South Texas Project Units 3 and 4 Docket Nos. 52-012 and 52-013 Response to Requests for Additional Information

Attached are responses to NRC staff questions included in Request for Additional Information (RAI) letter numbers 39 and 74, related to Combined License Application (COLA) Part 2, Tier 2, Sections 2.4S.12 and 2.3S.4, respectively. Attachments 1 through 4 include responses to the RAI questions listed below and complete the response to RAI letter numbers 39 and 74:

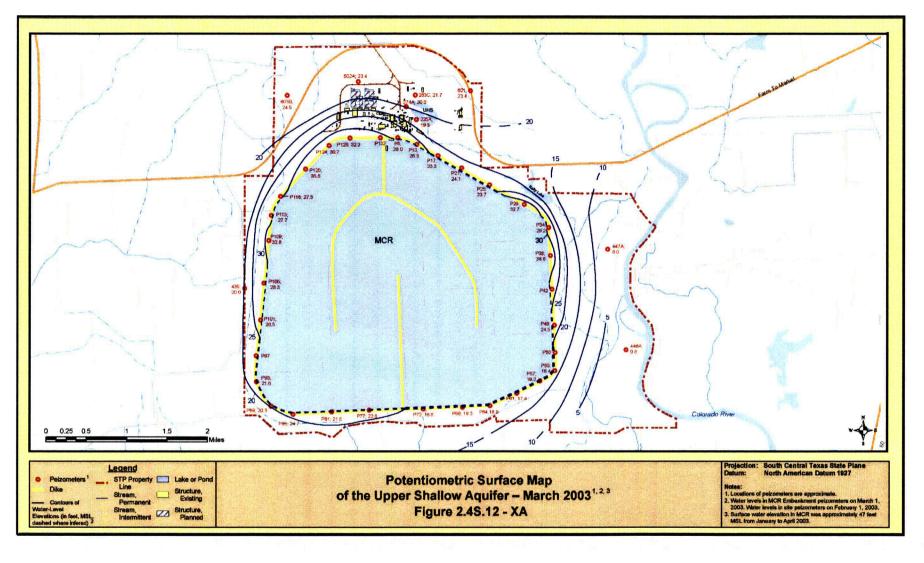
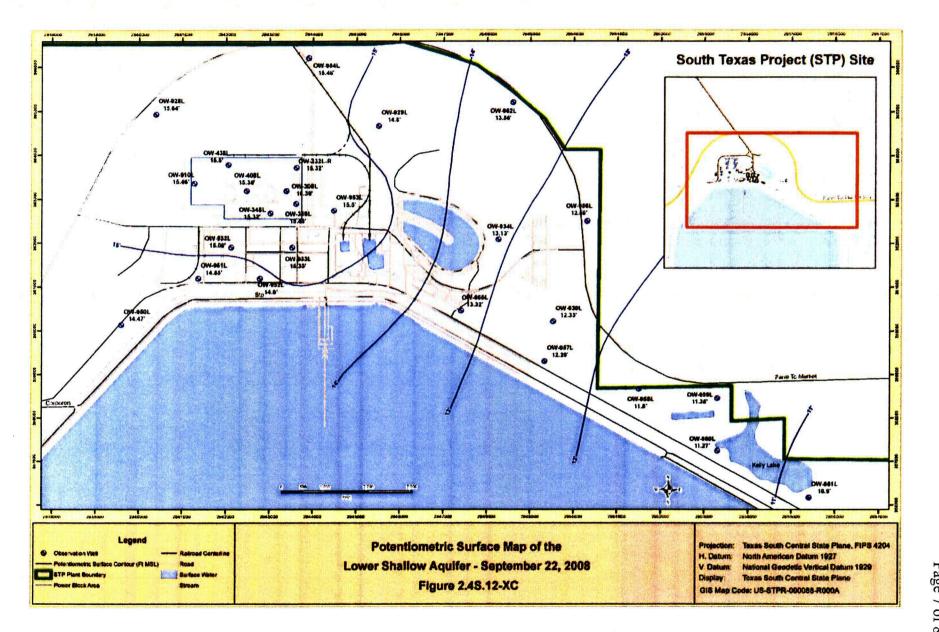
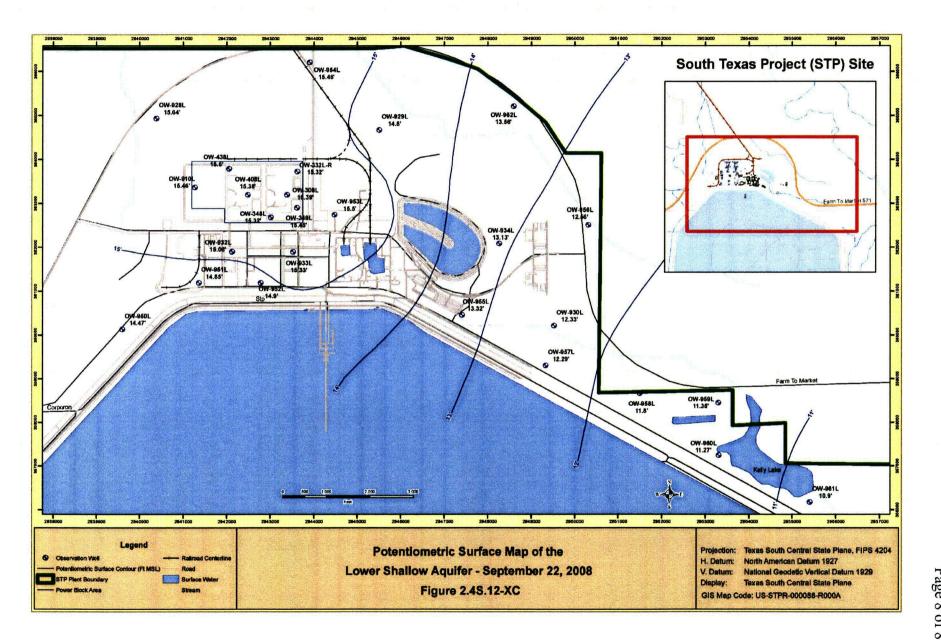
With regard to FSAR Figures 2.4S.12-17 and 2.4S.12-19: (a) while the groundwater head maps presented in these figures were used to determine contamination pathways, the staff recognize the following weaknesses in the presented information: (i) the groundwater head contours were drawn based on very limited observation data points, especially on the northeast side of MCR; (ii) while the applicant states that MCR water recharges into the Shallow Aquifer, the pattern of groundwater head distribution in and surrounding the MCR is not clearly defined (modified to address effects of MCR on exposure routes); and (iii) the projected pathways near the existing and new units are not clearly defined. Clarify the above issues and provide improved potentiometric surface maps. (b) discuss how the patterns of groundwater flow and pathways could change after the construction of the proposed units, and describe implications for the plausible pathways. (c) describe potential changes to the potentiometric surfaces of the Upper and Lower Shallow Aquifer and describe implications for the plausible pathways in cases of (i) continued greater usage of this resource (ii) prolonged periods of wet climate, and (iii) prolonged periods of dry climate. (d) Based on the above discussions and descriptions, provide refined post-construction pathway and travel time estimates in the Section 2.4S.12.3.1, "Exposure Point and Pathway Evaluation."

Historical groundwater levels measured in these piezometers indicate that the hydraulic head in the Upper Shallow Aquifer beneath the entire length of the MCR embankment decreases in the landward direction, inducing groundwater seepage outward from the MCR and toward the relief wells at the embankment toe. Figure 2.4S.12-XA is a contour map of water-level elevations in these piezometers in February 2003. This map shows the piezometric surface in the Upper Shallow Aquifer in the vicinity of the MCR, and indicates that groundwater flow was outward from the MCR along the entire length of the embankment.

Figure 2.4S.12-XB is a map of the potentiometric surface in the Upper Shallow Aquifer in September 2008. This map includes water levels in the original STP 3 and 4 observation wells drilled in 2006 and 2007, and supplemental observation wells drilled in 2008, and was prepared to support Commitments # 6, 7, and 8 (Reference 3). Figure 2.4S.12-XB shows groundwater flow outward from the MCR and diversion of flow to the southeast and southwest in the area of the STP 3 & 4 power block. To the northwest of the STP 3 & 4 power block the groundwater gradient is not affected by the MCR and is toward the power block. Flow from this area converges with the outward flow from the northwest corner of the MCR and is diverted around the MCR, to the southeast and the southwest.

Figure 2.4S.12-XC is a map of the potentiometric surface in the Lower Shallow Aquifer in September 2008. This figure shows that groundwater flows from northwest to southeast, under the area of the STP 3 & 4 power block, toward and under the MCR. Groundwater flow in this aquifer does not appear to be significantly affected by seepage from the MCR.
